DART SERVICE INSTRUCTION

TO AMEND INSTALLATION INSTRUCTIONS IIN-D205-633 REV. B AND
INSTRUCTIONS FOR CONTINUED AIRWORTHINESS ICA-D205-633 REV. 1

REF. CANADIAN STC: SH96-57

FROM FIGURE 5 (IIN-D205-633) AND FIGURE 25-5 (ICA-D205-633)

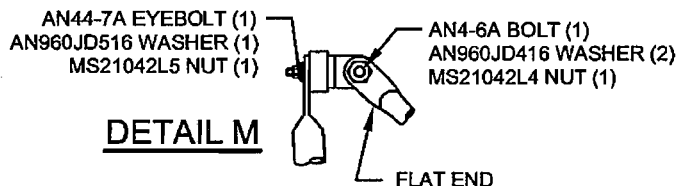
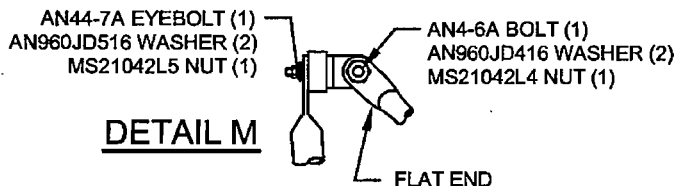
FOR THE D205-633-013/-015 HELI-ACCESS-STEPS™, THE WRONG QUANTITY OF AN960JD516 WASHER IS SHOWN IN DETAIL M AND THE PARTS LIST.

FOR THE D205-633-013/-015 HELI-ACCESS-STEPS™, DETAIL M AND THE PARTS LISTS ARE UPDATED AS FOLLOWS:

IS:

WAS:
